**From:** Johanning, Jeffrey R. <JEFFREY.R.JOHANNING@leidos.com>  
**Sent:** Wednesday, June 20, 2018 7:25 PM  
**To:** Valentin-Rodriguez, Celimar  
**Cc:** Herrera, Tomas  
**Subject:** [External\_Sender] RE: Questions on new amendment (Doc # 030-38634)  
**Attachments:** Xpose LBL.pdf; 702735 X1 - Top Assy.PDF

**From:** Johanning, Jeffrey R. [<mailto:JEFFREY.R.JOHANNING@leidos.com>]  
**Sent:** Thursday, June 14, 2018 2:34 PM  
**To:** Valentin-Rodriguez, Celimar <[Celimar.Valentin-Rodriguez@nrc.gov](mailto:Celimar.Valentin-Rodriguez@nrc.gov)>  
**Cc:** Struckmeyer, Richard <[Richard.Struckmeyer@nrc.gov](mailto:Richard.Struckmeyer@nrc.gov)>  
**Subject:** [External\_Sender] Questions on new amendment (Doc # 030-38634)

I do want to check on a couple items for our SSDR (NR-1373-D-101-E).

SH REV A  
1  
DWG NO 701422

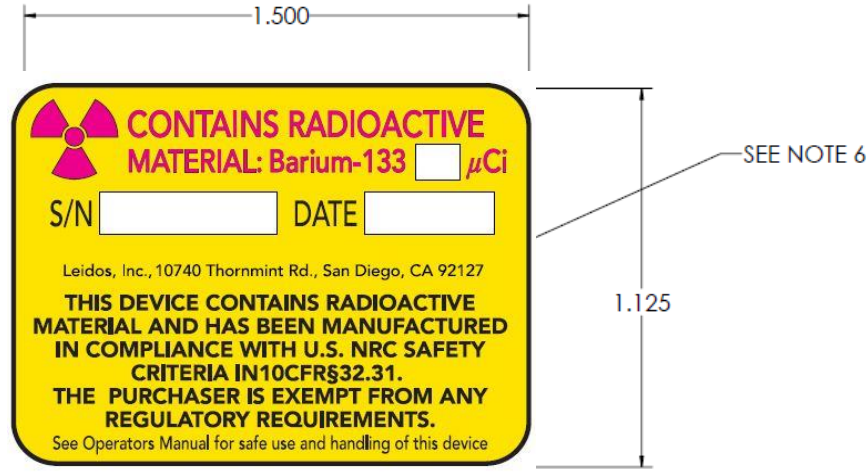
- Attachment 1: This attachment is a picture that is quite outdated. It shows our old company name (SAIC). Attachment 5 from our amendment request dated 4/23/18 (ML18123A484) may serve as an updated picture that also shows our new IP-56 top cover.
- Attachment 2: This attachment for Xpose maintains the activity as currently preprinted on the label; and Attachment 3 has the new label where the activity is stamped by us. If you would like, I can provide you an equivalent Attachment 2 except for the preprinted activity, with approx dimensions that agrees with attachment 3.

Greetings Ms. Valentin-Rodriguez,  
Attached are some updated drawings that may serve better than the Attachments that are currently in the SSDR.
